RECOMMENDED SERVICE BULLETIN NO. RSB40-011/1

Starter relay.

WI-RSB40-011/1

„STARTER RELAY INSTALLATION“

DA4-2466-10-00"b"

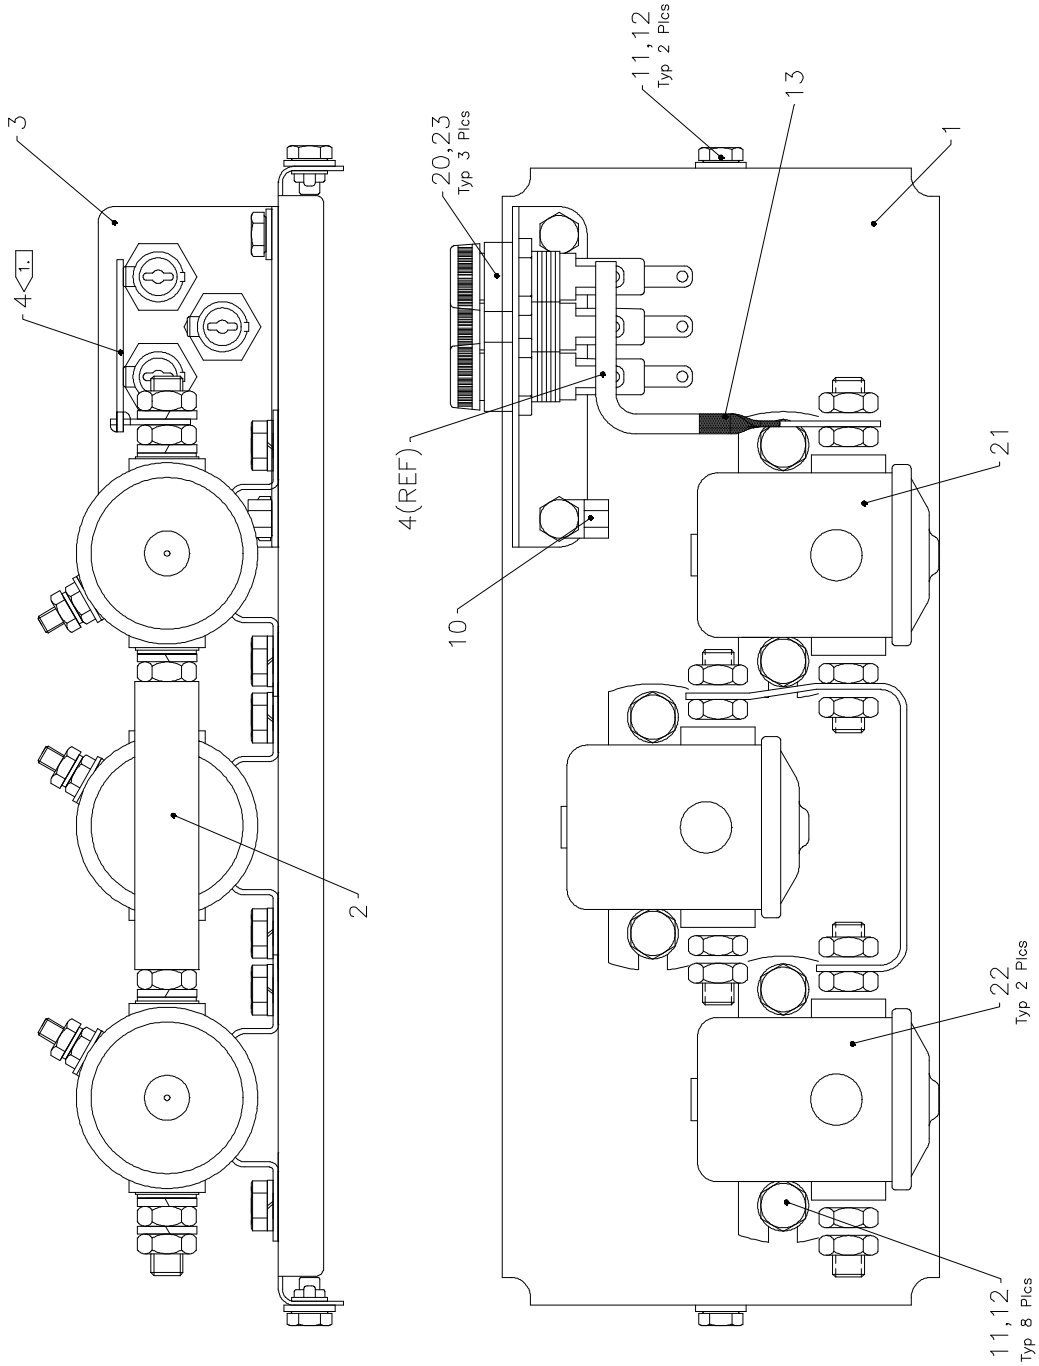
1	Remove upper cowling
2	Disconnect battery (negative pole first)
3	Release relay box cover
4	Disconnect cables
5	Remove starter cable (no. 80104 A4)
6	Remove the complete relay panel (item 1, dwg. no. DA4-2466-10-00"b")
7	Remove bus bar and hot battery bus (items 2 and 4, dwg. no. DA4-2466-10-00"b")
8	Release all three relays
9	Release fuse holders (items 20, dwg. no. DA4-2466-10-00"b") from the fuse holder bracket (item 3, dwg. no. DA4-2466-10-00"b")
10	Remove fuse holder bracket (item 3, dwg. no. DA4-2466-10-00"b")
11	Install new starter cable part # 17.6011 in accordance with the Airplane Maintenance Manual Doc No. 6.02.01
12	Install spacer part # 17.6015 with C.S. Bolts part # MS24693-S274, Lock Nut part # MS21044N3 and washer part # 11.5210 on Kissling relay part # 17.6002 (items 5, 7, 9, 12, 24, dwg. no. DA4-2466-10-00"d")
13	Install EPU relay (S-1577A1) and battery relay (S-1580A1) (items 22 and 21, dwg. no. DA4-2466-10-00"d") on new relay panel part # 17.6020

DA4-2406-30-00"a"

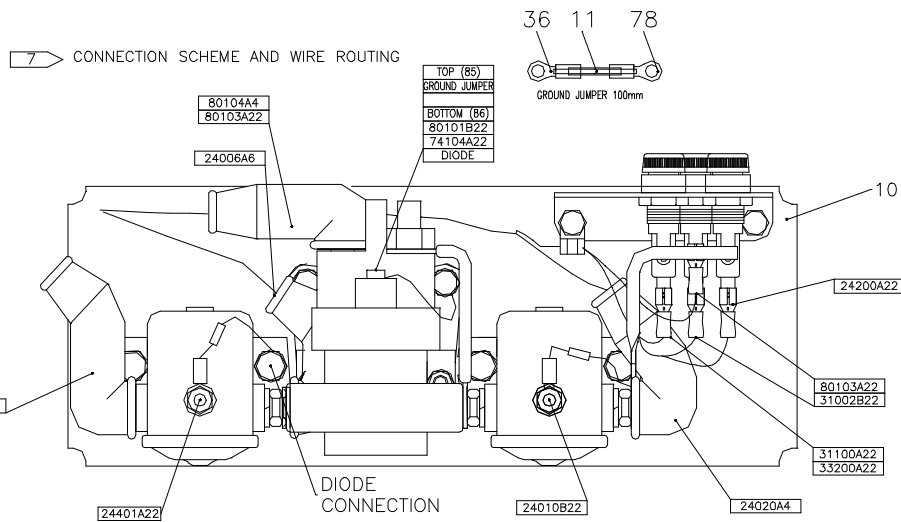
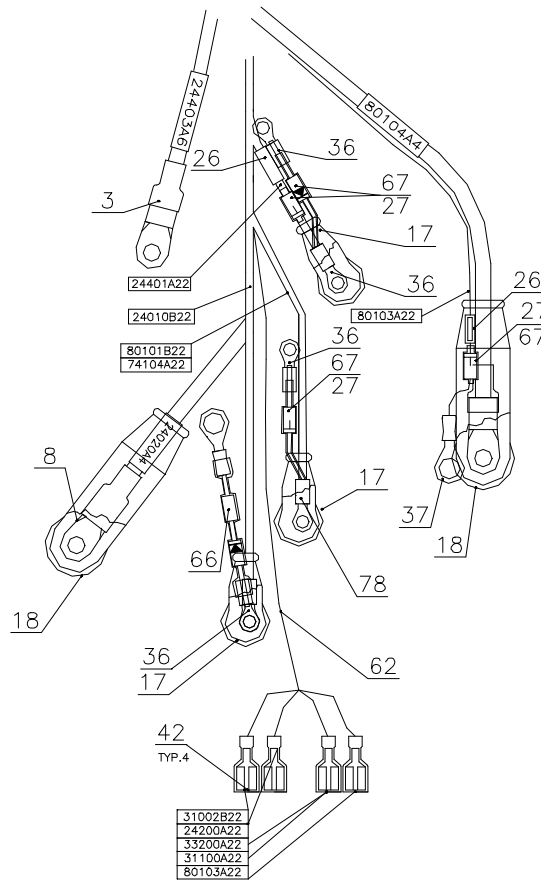
14	Build ground cable from ring terminals 17.6018, 17.6019 and wire 17.1590 in accordance with dwg. no. DA4-2406-30-00"a" (items 36, 11, 78)
15	Install new ring terminals part # 17.6022 (item 37, dwg. no. DA4-2406-30-00"a") on wire # 80103A22 and part # 17.6019 (item 78, dwg. no. DA4-2406-30-00"a") on wire # 80101B22/74104A22/ Diode)
16	Install ground cable on the starter relay connection 85 in accordance with dwg. no. DA4-2406-30-00"a"

17	Install Kissling starter relay part # 17.6002 (item 24, dwg. no. DA4-2466-10-00"d") on new relay panel part # 17.6020 with bolts part # 11.5300 (item 8, dwg. no. DA4-2466-10-00"d") and washers and connect the ground cable in accordance with dwg. no. DA4-2406-30-00a
18	Install bus bar part # 17.6017 with heat shrinks part # 17.0854 (items 2 and 14, dwg. no. DA4-2466-10-00"d")
19	Install fuse holder bracket part # 17.6010 (item 3, dwg. no. DA4-2466-10-00"d")
20	Install fuses and fuse holders (items 20 and 23, dwg. no. DA4-2466-10-00"d")
21	Install hot battery bus part # 17.6016 and heat shrink part # 17.0851 (items 4 and 13, dwg. no. DA4-2466-10-00"d"). Solder bus to fuse tab
22	Install assembled relay panel
23	Connect cables
24	Check for foreign objects
25	Ensure a tight fit of all parts
26	Install the new relay box cover part # 40.1530
27	Connect battery
28	Install upper cowling
